Stephens Hillside Farms Preliminary Subdivision

2018-016-SUB

348th St Extension

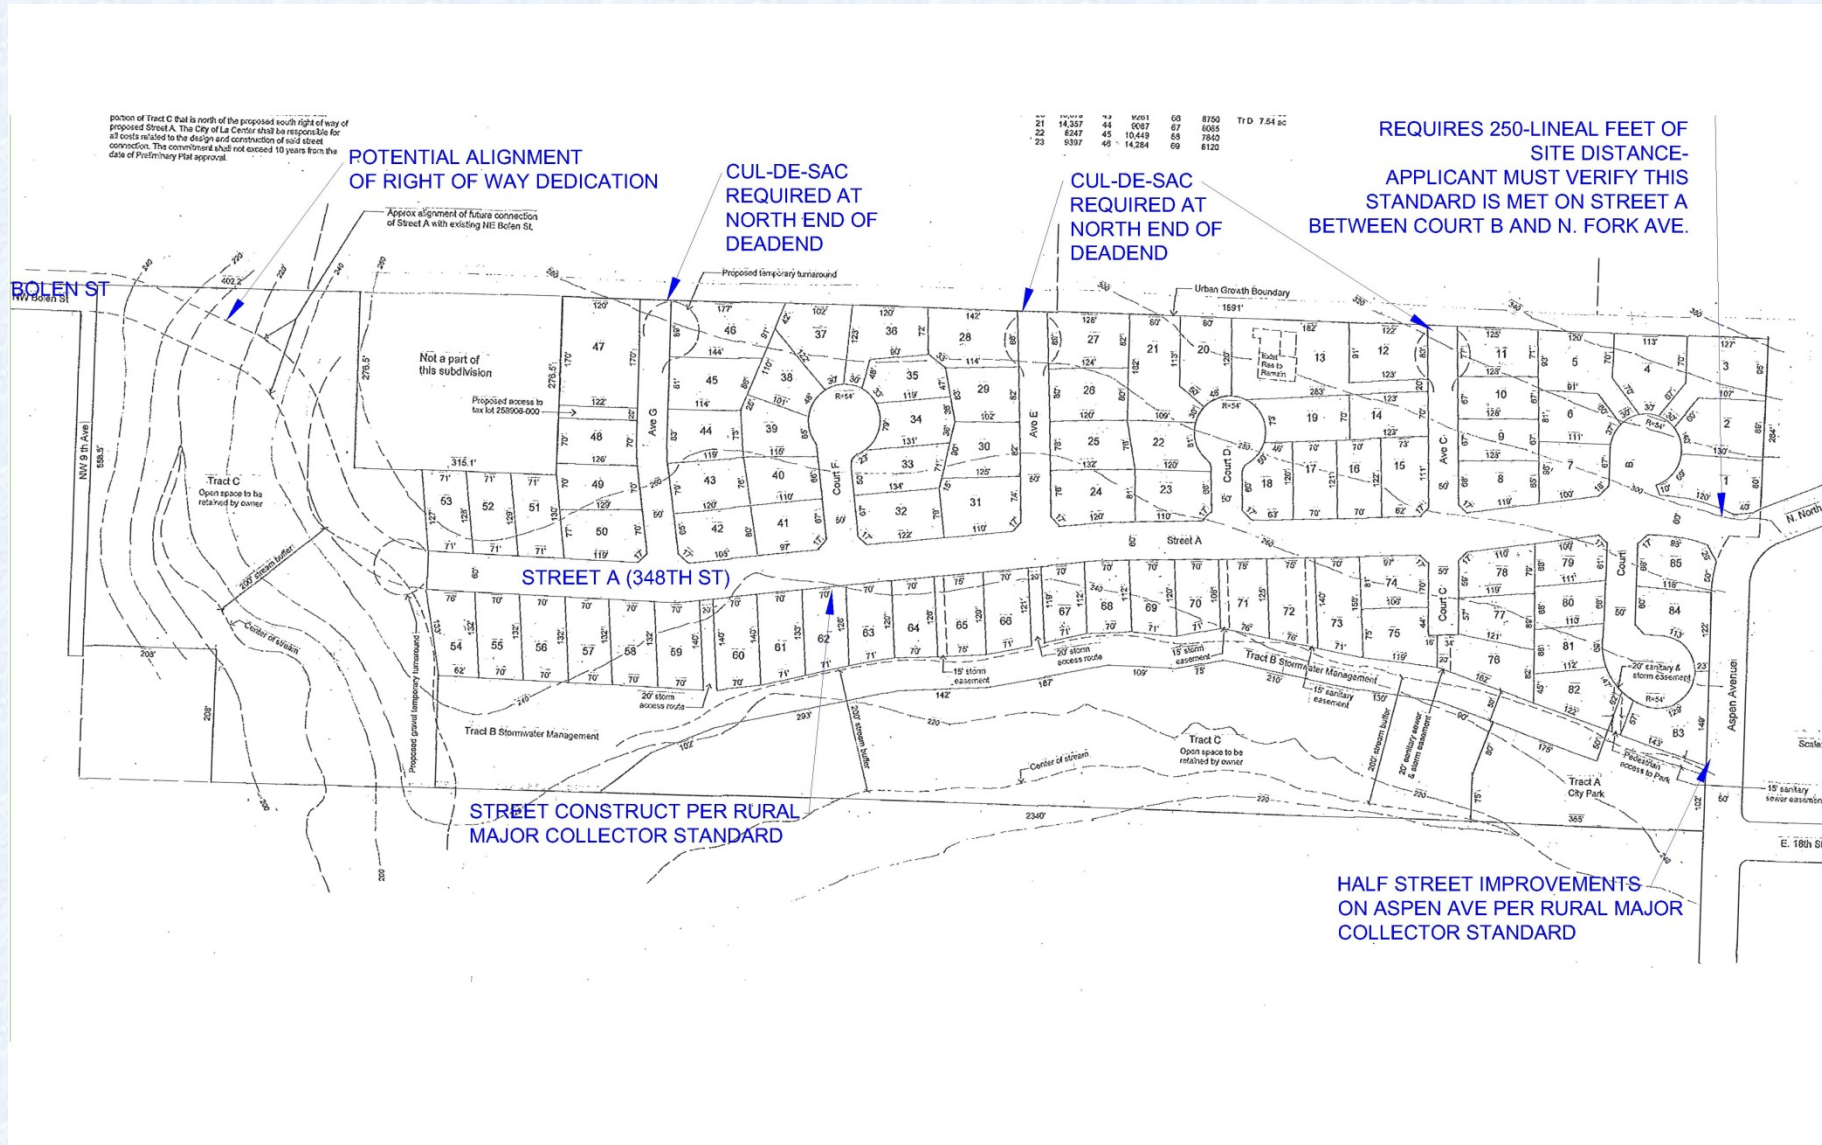
Transportation CFP anticipates the extension of NW 348th Street and the connection between the western terminus of NW 348th Street and Bolen Road as a Major Collector.

- To help mitigate for potential adverse effects, the subdivision plat shall carry the following note:
- *“The applicant has voluntarily agreed to voluntarily and irrevocably commit to a dedication of right-of-way for a future street connection from the westerly terminus of proposed Street A (348th St.) of Stephens Hillside ~~Estates~~Farms Subdivision across proposed Tract C to connect with the easterly terminus of existing NE Bolen Street, the exact route to be determined within a reasonable time frame. The commitment shall encumber that portion of Tract C that is north of the proposed south right-of-way of proposed street A. The City of La Center shall be responsible for all costs related to the design and construction of said street connection. The commitment shall not exceed ten (10) years from the date of preliminary plat approval.”*
